# RATHGEBER NATURAL RESOURCE PARK

## Trail Study Presentation

# Recommendations: Northern Trail System

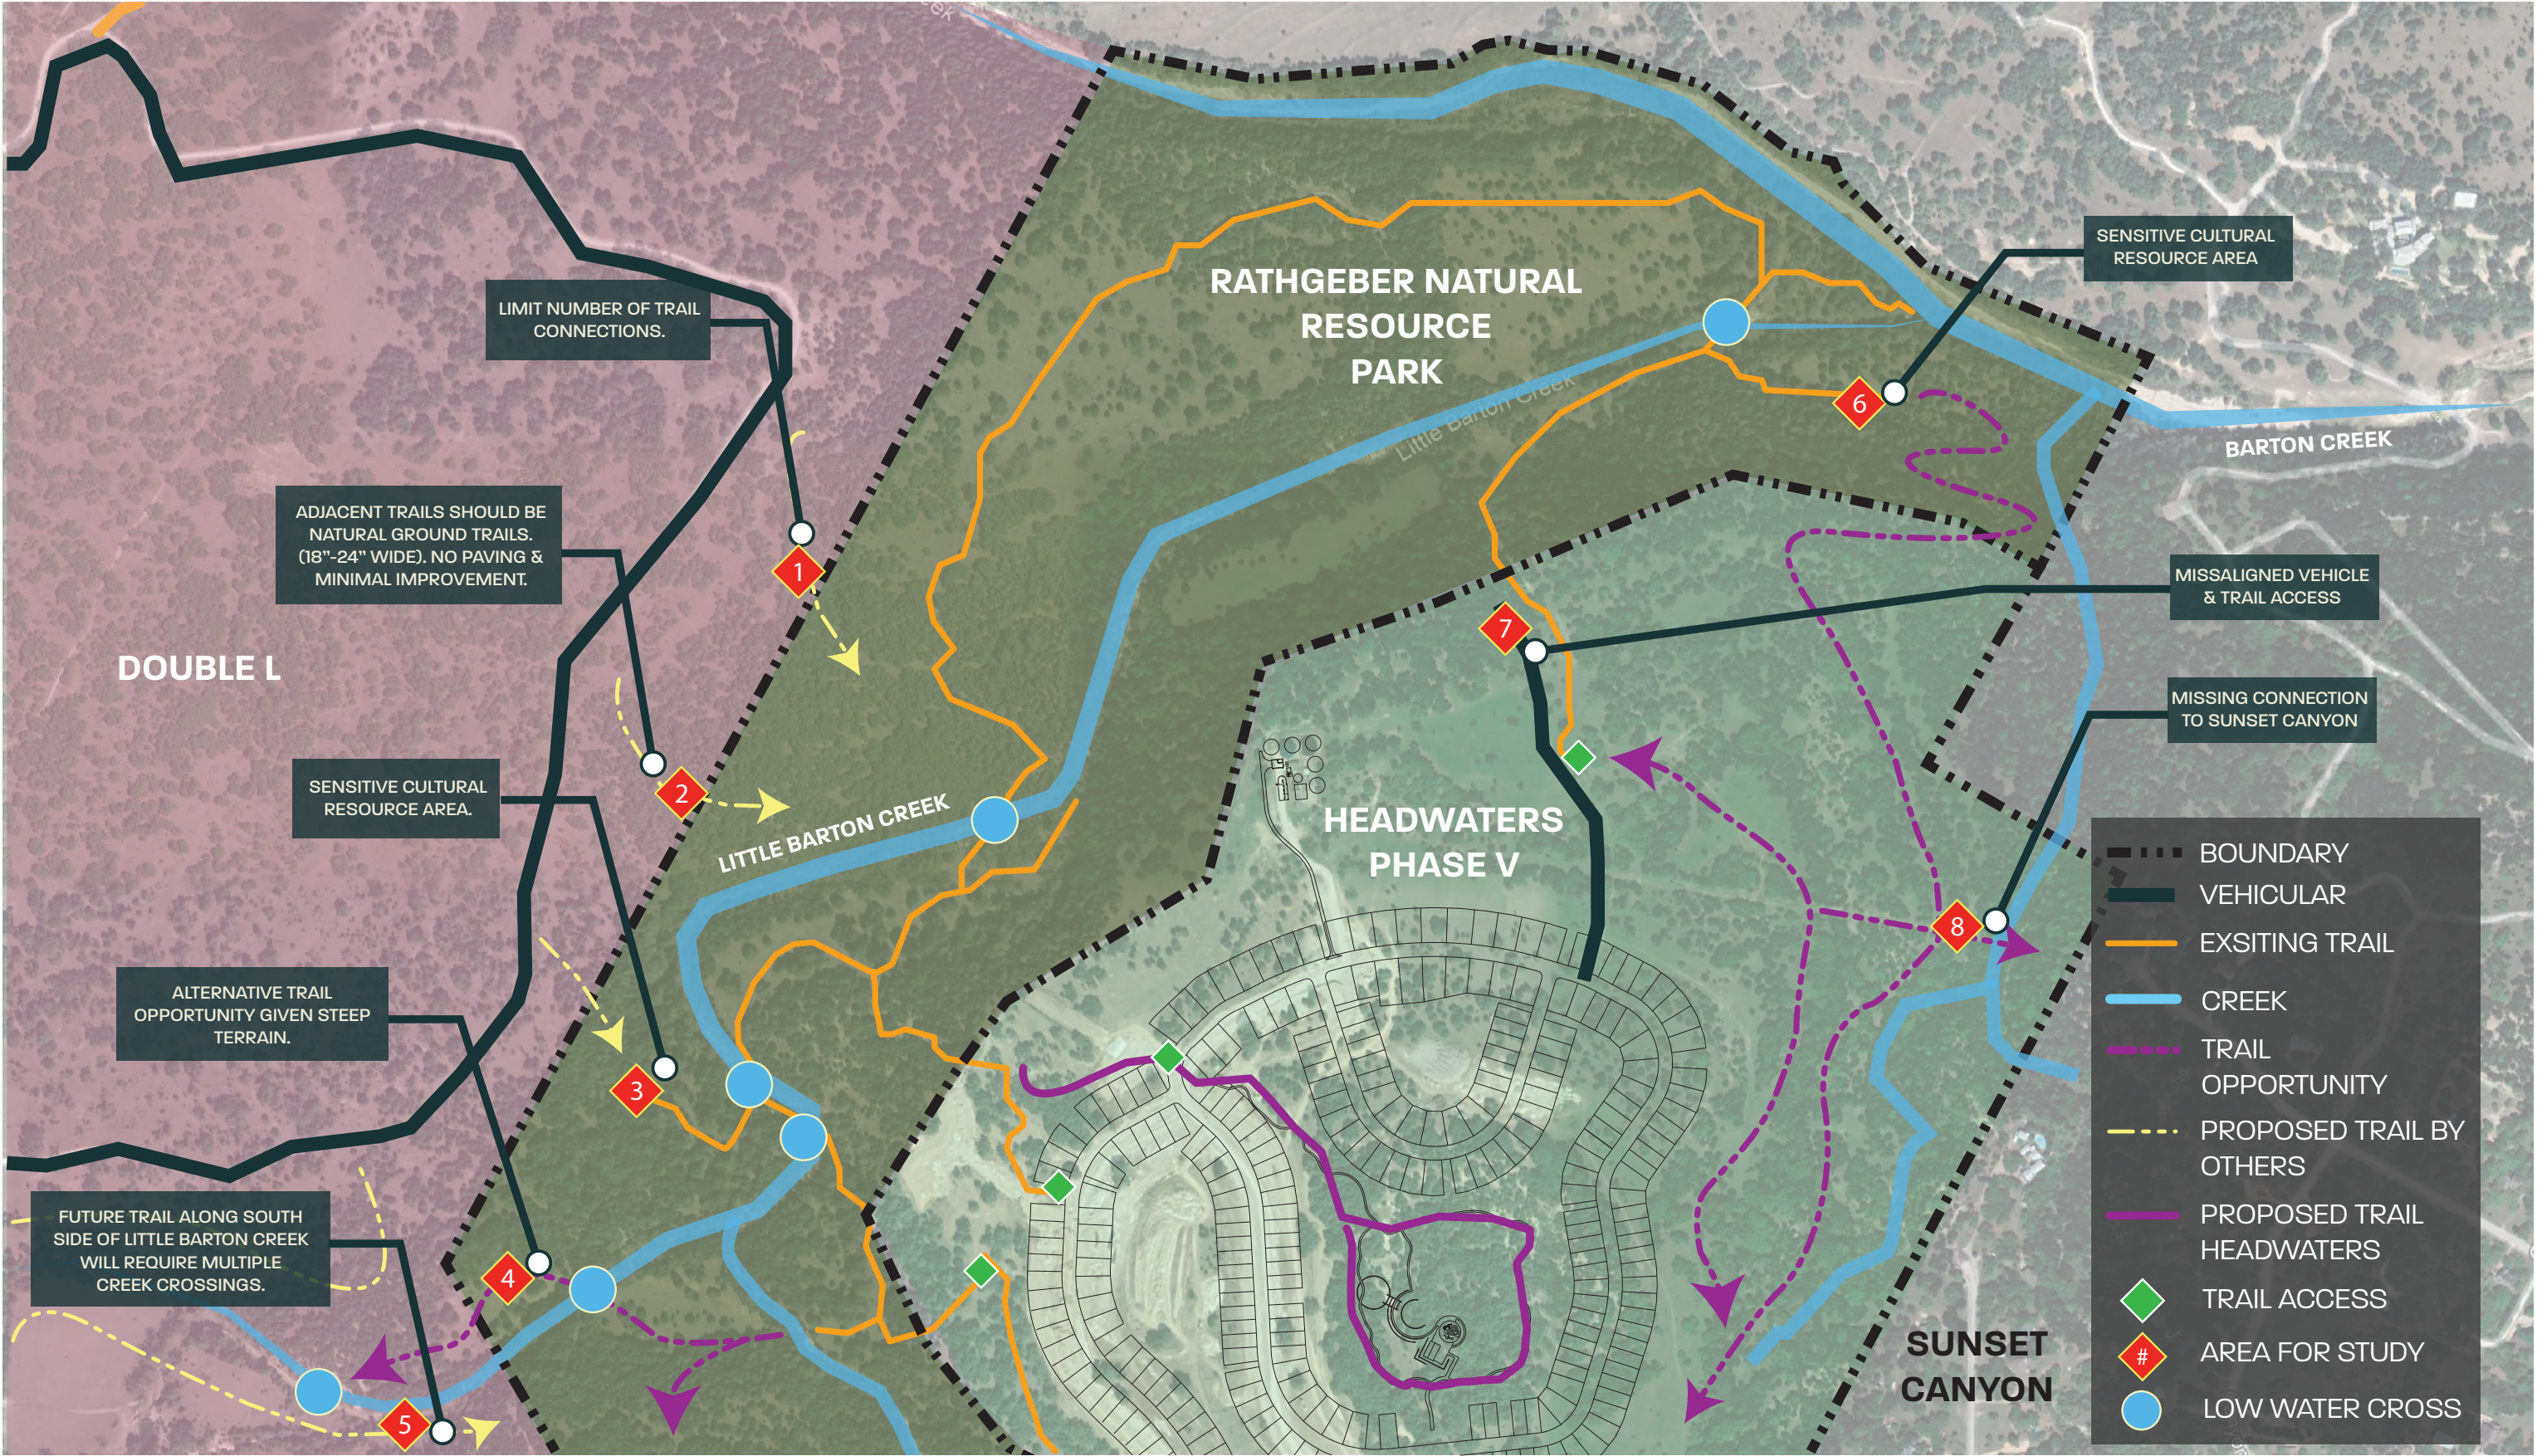
-  Trail connections from future “Double L” development leading into Rathgeber park should be limited to preserve wilderness experience within the park. These proposed trails also connect to parts of Rathgeber that lack an existing trail.
-  Any adjacent trails connecting to Rathgeber Park should be natural ground trails that require no paving and minimal changes. (18”-24” wide).
-  Sensitive cultural resource sites should be protected or left undisturbed by trail system.
-  An alternative (long distance) trail should be explored north of “Little Barton Creek” due to the steep terrain on the south side.
-  This trail along “Little Barton Creek” will require multiple creek crossings as the cliffs prevent passage solely on one side of the creek.

-  The exisiting sensitive cultural resource site should be protected here. (Discussion over this site needed for full context.)

-  A vehicular road was cleared to the tree line (as depicted in Headwaters Masterplan - ” Easement”) and does not align with the existing trail entering into Rathgeber Park.
-  There could be a potential trail opportunity along the eastern boundary of the Headwaters development with a pedetrian connection into Sunset Canyon.

# Recommendations: Southern Trail System

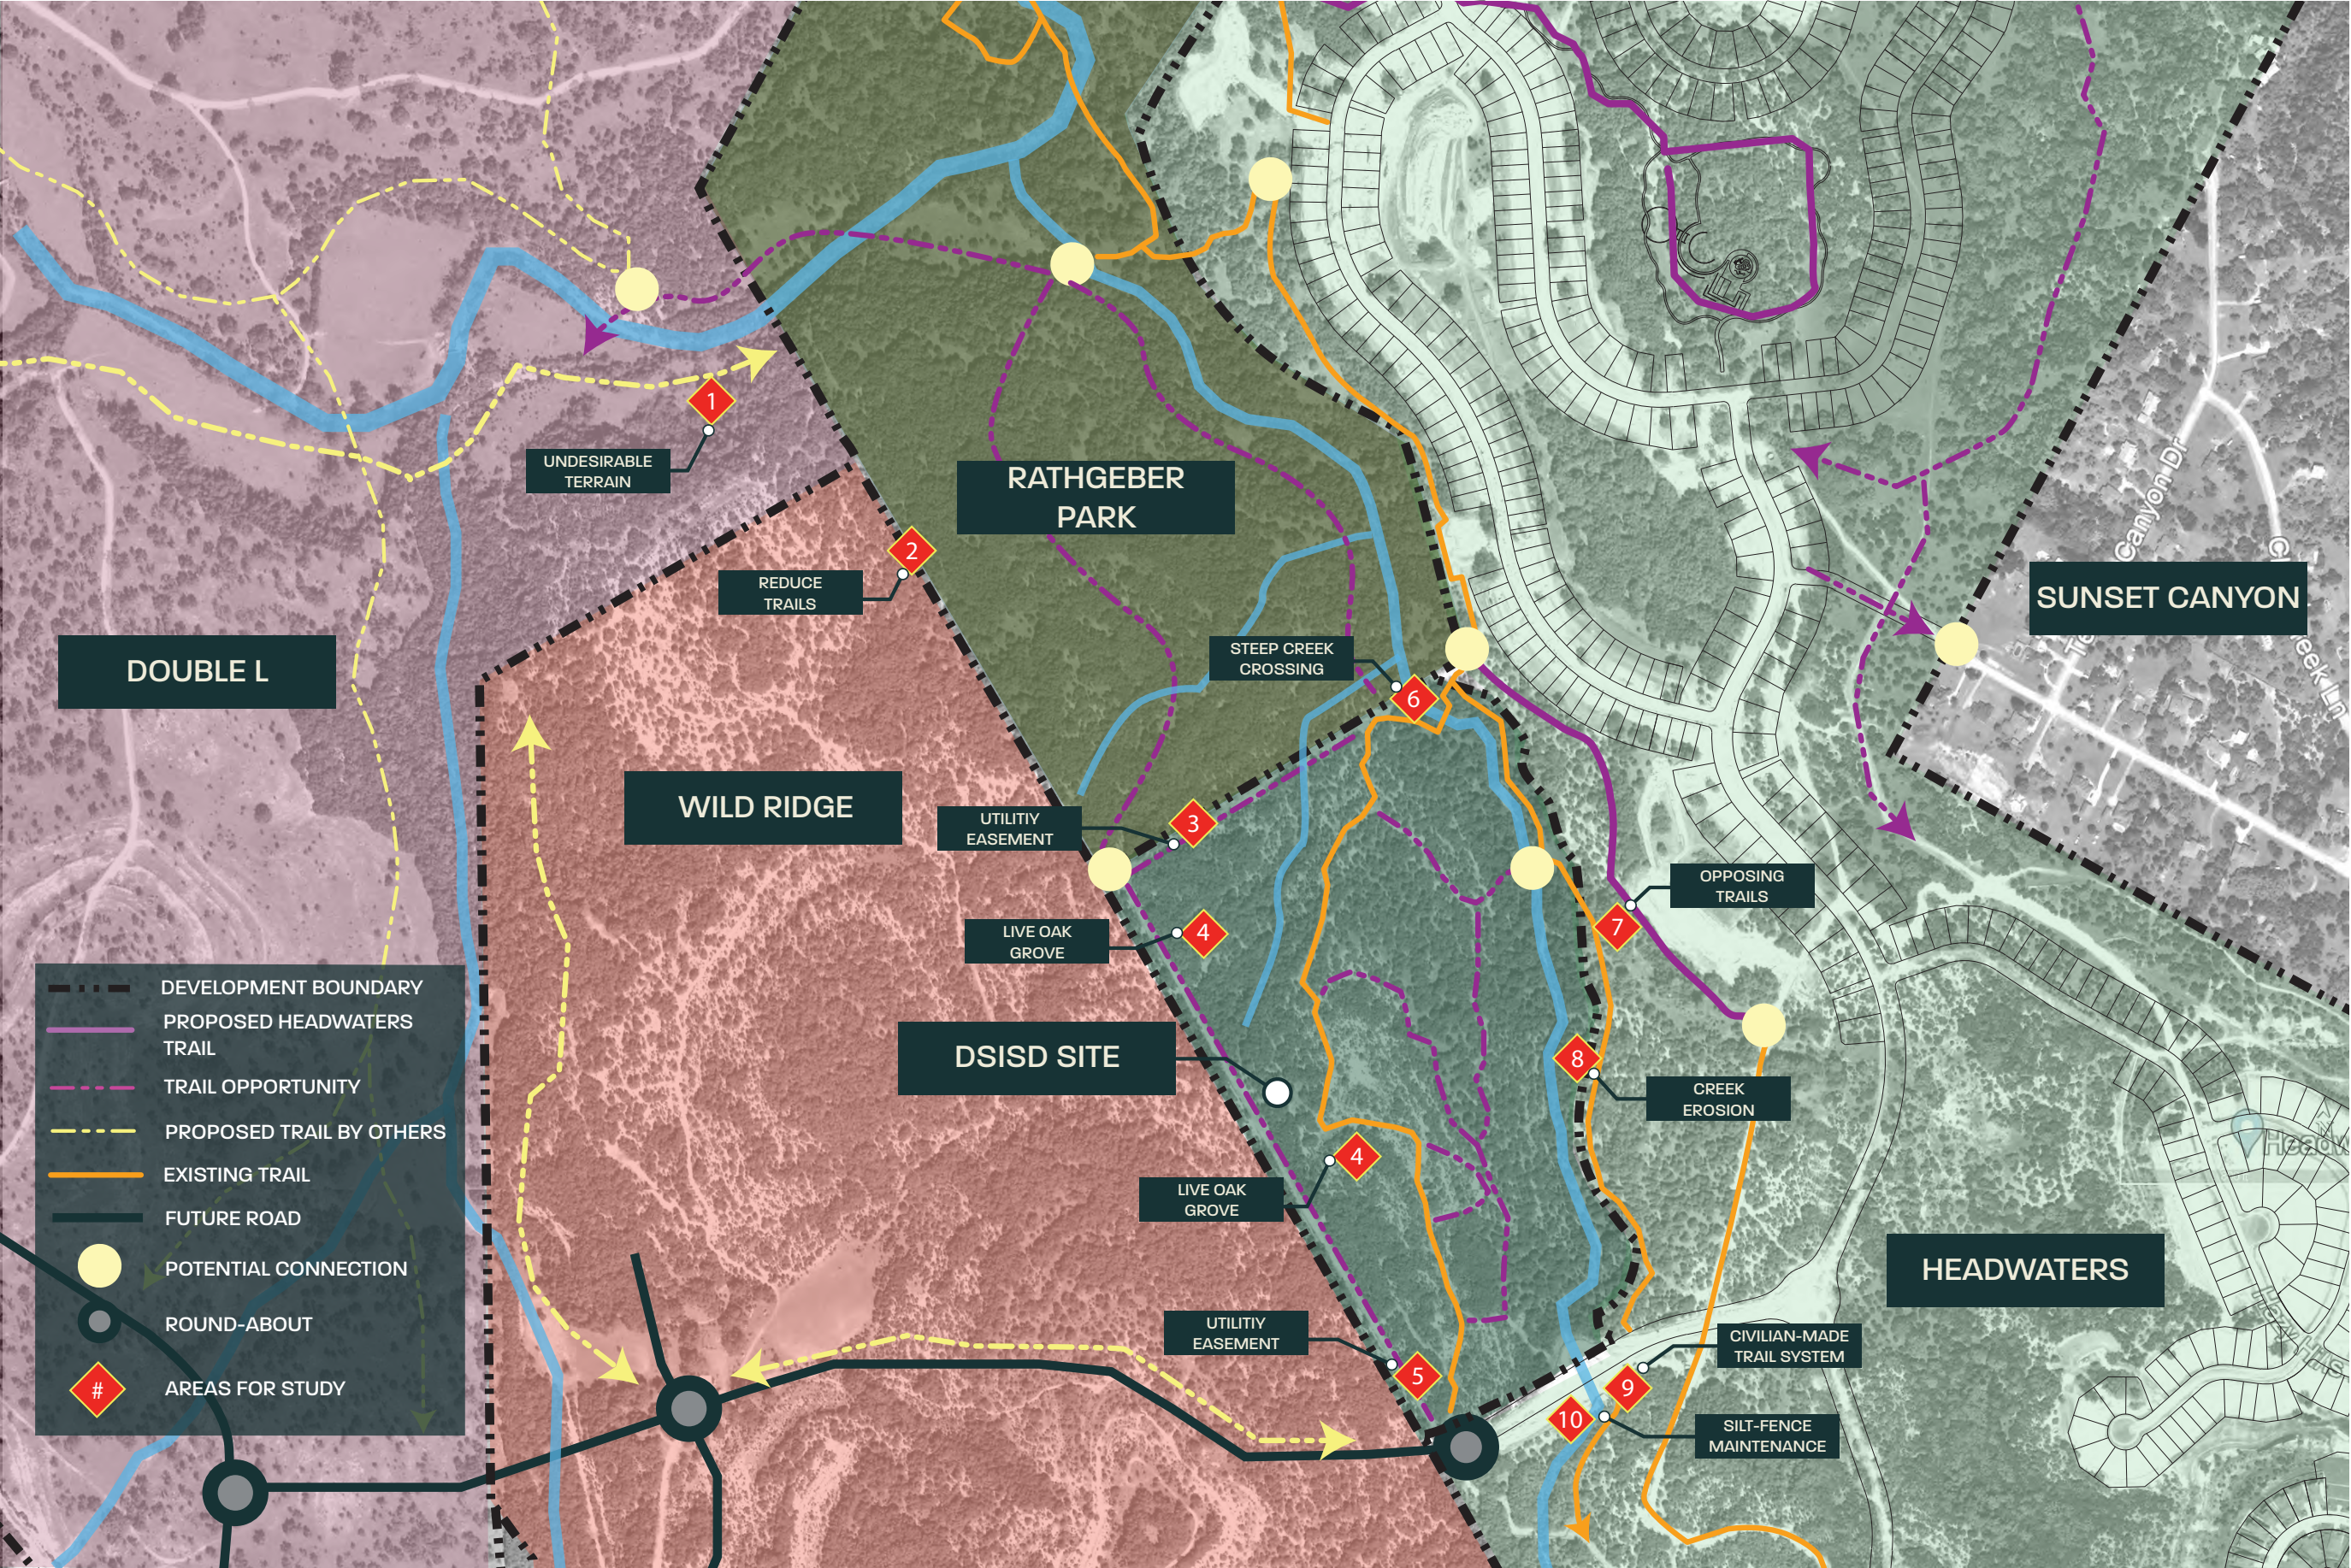
**1** This proposed long range trail may be placed in steep terrain unsuitable for pedestrian trails. An alternative trail opportunity has been shown in the northern side of “Little Barton Creek”.

**2** We recommend limiting connections from Cynosure into Rathgeber Park due to the proximity of what could be a designated “main entrance” at the DSISD school site or Interpretive Center. This will help the city control entry/access into the park, as well as preserve more of the sensitive wilderness areas from parking and high pedestrian traffic.

- 3** Existing utility lines provide cleared areas that will probably be used as “unofficial” trails by pedestrians and visitors. This location could be a used as a potentially connection to other official trails.
- 4** Live Oak groves are scattered among the site and should be investigated during school site planning.
- 5** Another existing utility line that will be used by park visitors as an “unofficial” trail.
- 6** Steep slope observed at this location that will prevent connection to Headwaters and Rathgeber Park. Another low-water crossing is marked as a suitable alternative.
